EM13-007a

## 2013-2014 SENTRA; **ENGINE UPPER TORQUE ROD SERVICE INFORMATION**

NTB14-003a

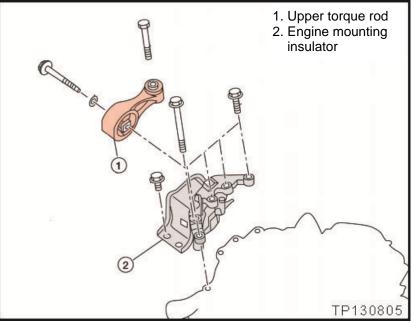
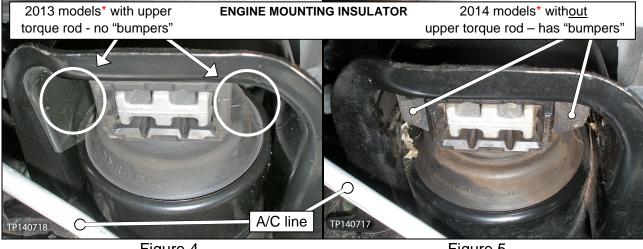
These vehicles have an engine mounting insulator that requires an upper torgue rod. •

2014 Sentra: All SV, SL, and SR models DO NOT HAVE an upper torgue rod. DO NOT INSTALL an upper torque rod on these models for any reason.

- These vehicles have a redesigned engine mounting insulator that does not require an upper torque rod.
- \* 2014 Sentra: S models built BEFORE 3N1AB7AP(\*)EL 606447 and November 2, 2013 are equipped with an upper torque rod.
  - These vehicles have an engine mounting insulator that requires an upper torque rod.

2014 Sentra: S models built ON and AFTER 3N1AB7AP(\*)EL 606447 and November 2, 2013 DO NOT HAVE an upper torque rod. DO NOT INSTALL an upper torque rod on these models for any reason.

These vehicles have a redesigned engine mounting insulator that does not require an upper torque rod.
